## **COMMITTEE OF THE WHOLE MARCH 4, 2002**

### **SITE DEVELOPMENT APPLICATION FILE DA.01.096 1385329 ONTARIO INC.**

## ATTACHMENT '2' SITE PLAN

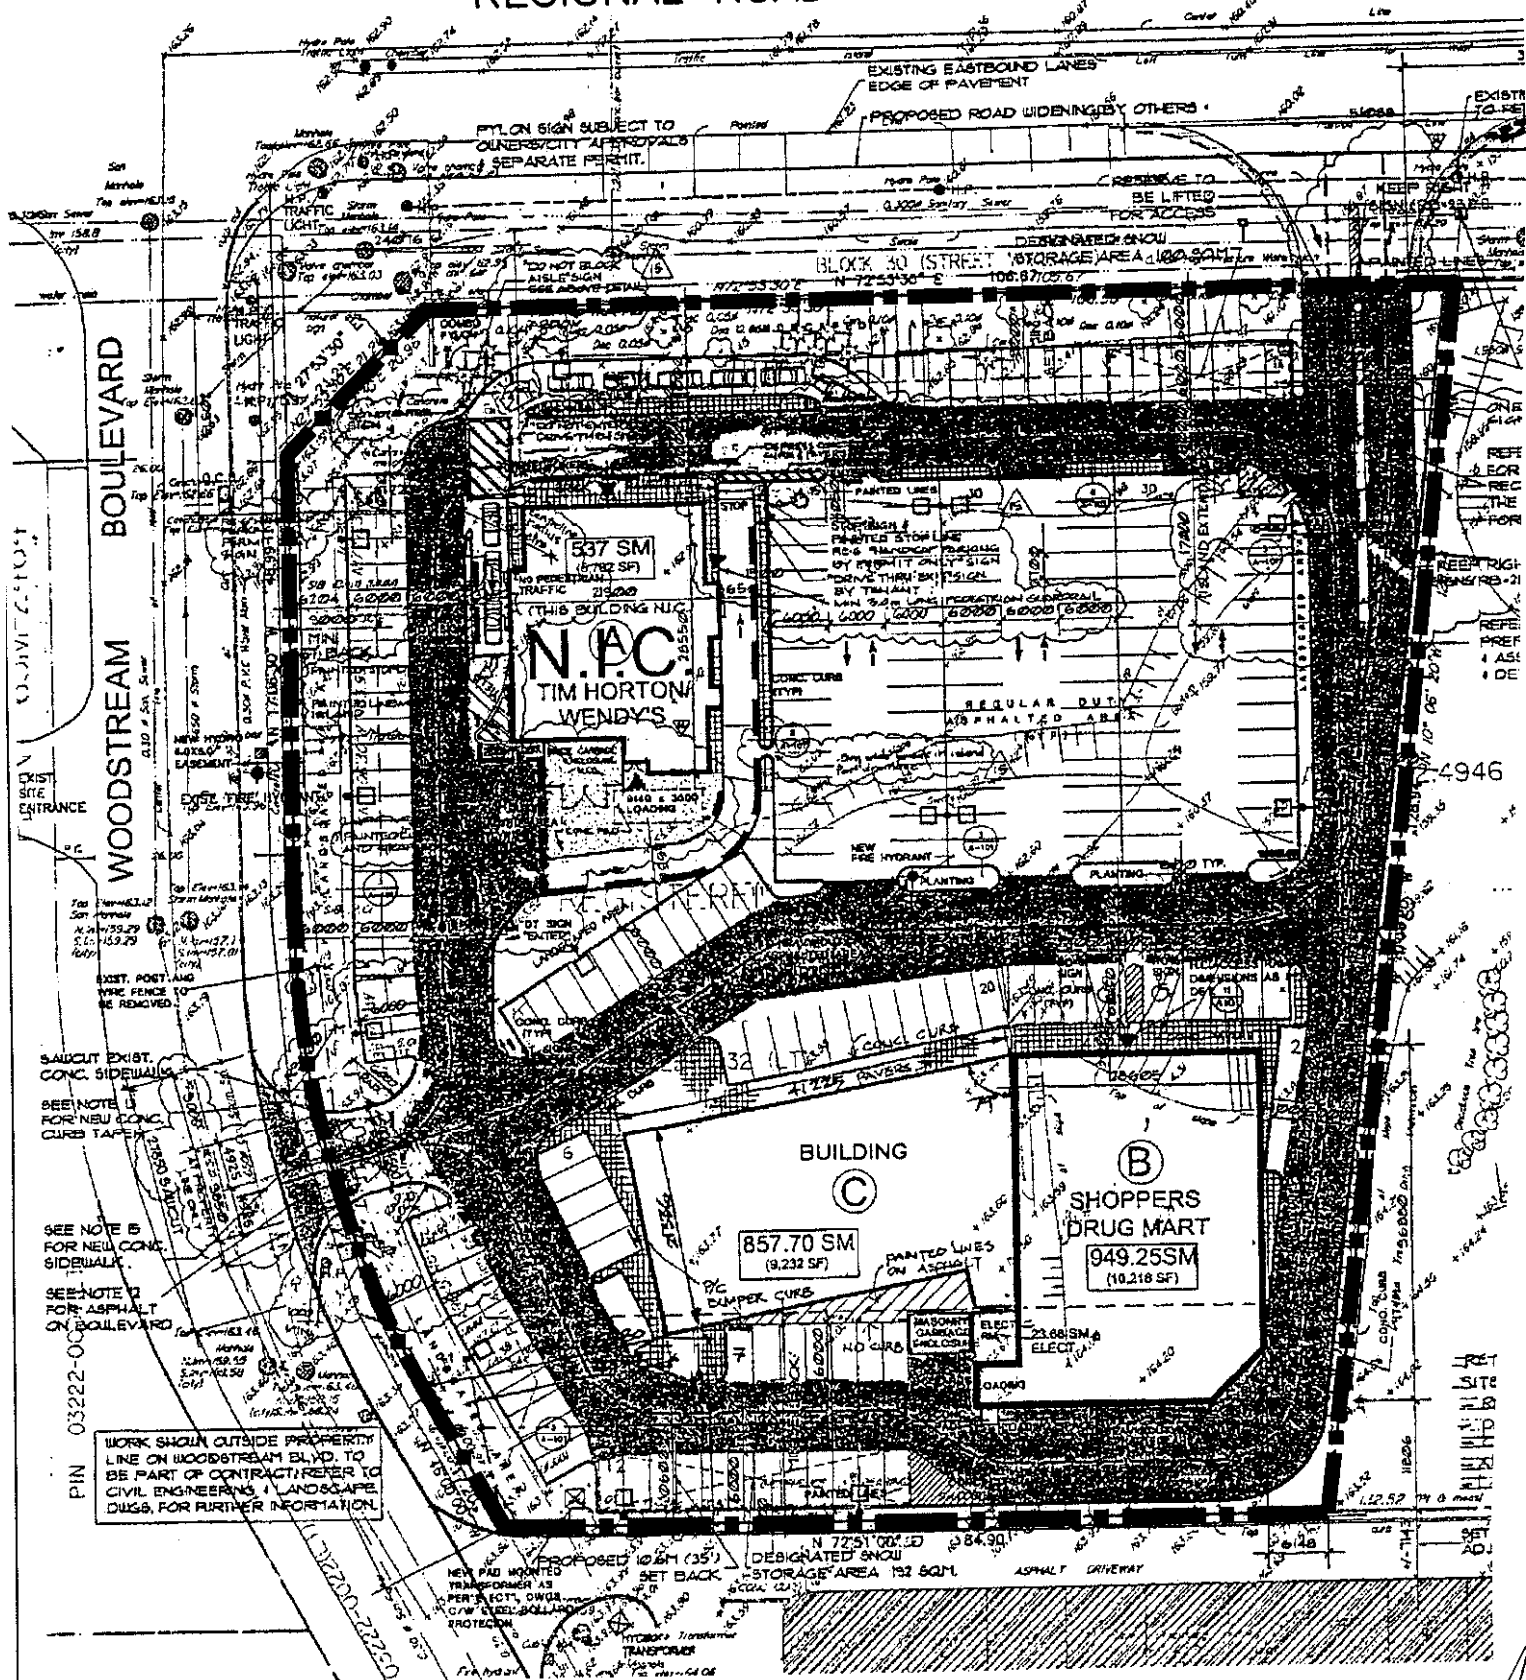
Buildings 'A' and 'B' are existing, as is the parking and landscaping. Building 'C', which is a one-storey 857.7 m<sup>2</sup> addition to the west side of Building 'B', is the subject of this application.

The rear yard setback is shown as 20.023 m, whereas 22 m is required by the by-law. An application to the Committee of Adjustment will be required to permit this variance.

A parking count on the site plan indicates that there are 195 parking spaces, whereas 196 spaces are required. A parallel parking space on the west side of Building 'C' may need to be deleted, as it is in an awkward location. As such, two parking spaces will need to be added, or a variance granted to permit this deficiency.

ATTACHMENT '3' ELEVATIONS	FILE #:	REPORT #:	DATE: 01/10/2002
	DA.01.096	PT. OF LOT 5, CON. 8	SCALE: NOT TO SCALE
		CITY OF VAUGHAN PLANNING DEPARTMENT	APPLICANT: 1385329 ONTARIO INC.

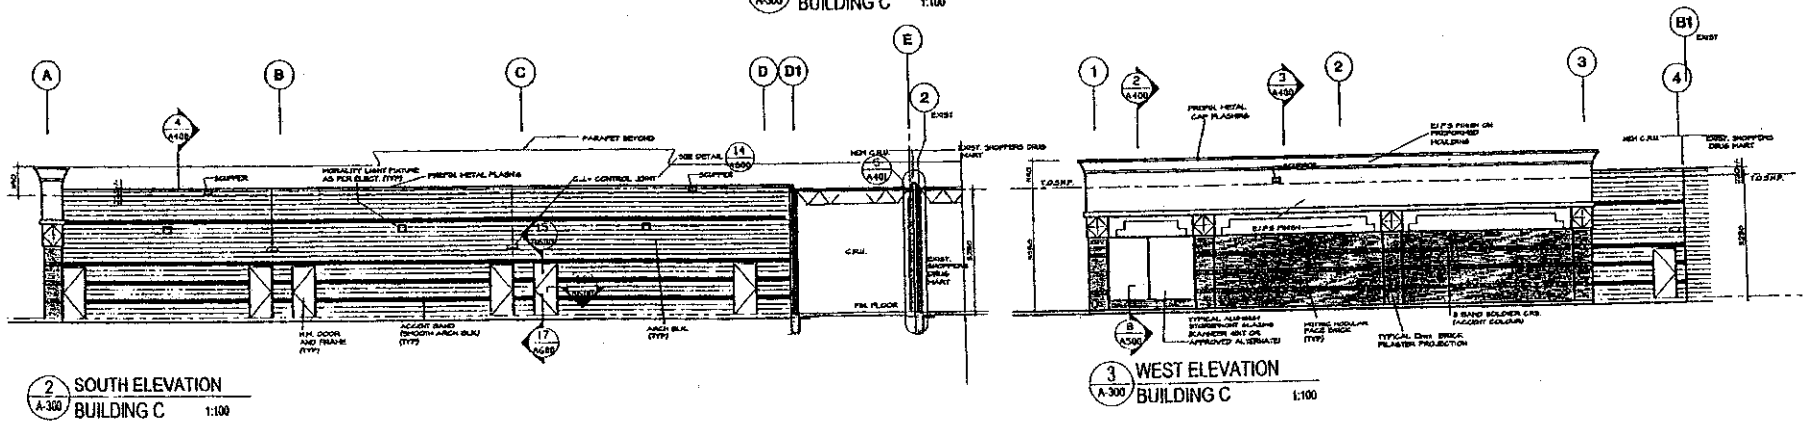
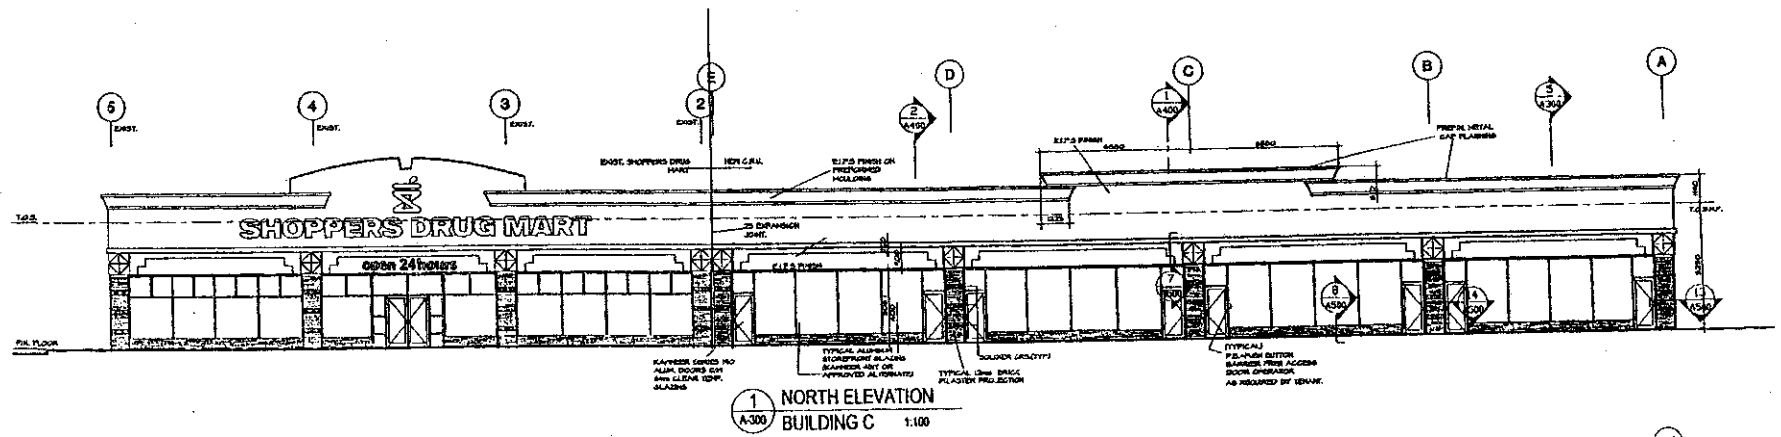
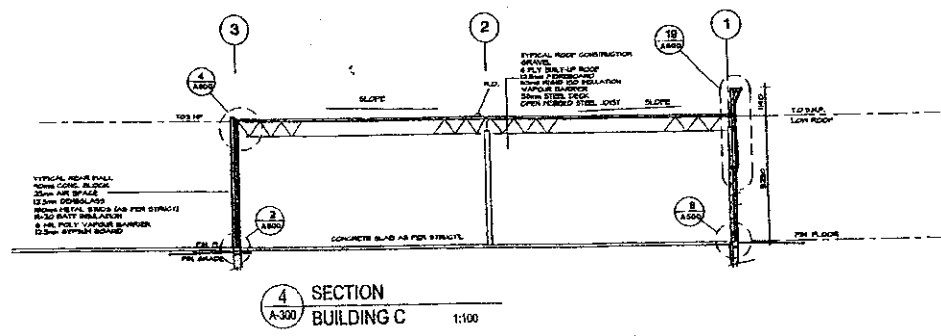
The front (north) elevation, which faces Highway #7, will be predominantly glass with doors to the individual units. There is red brickwork between the units and along the base of the building. Immediately above the glass will be a band for signage. Above the signage is a light-beige area of pre-finished material that will match the existing finish on Building 'B'. Along the top will be a molded parapet, which will be raised in the middle of the building for added detail.

The west elevation, facing Woodstream Boulevard, will have one section of windows, and the remaining three-quarters will be red brick. There will be a sign band, above which the same beige pre-finished material will continue from the front elevation.

The rear elevation faces an existing industrial building to the south. This elevation will be red brick with service doors to the individual units. The parapet along the roof line will screen the roof-top mechanicals from the north and west. No additional screening is required.
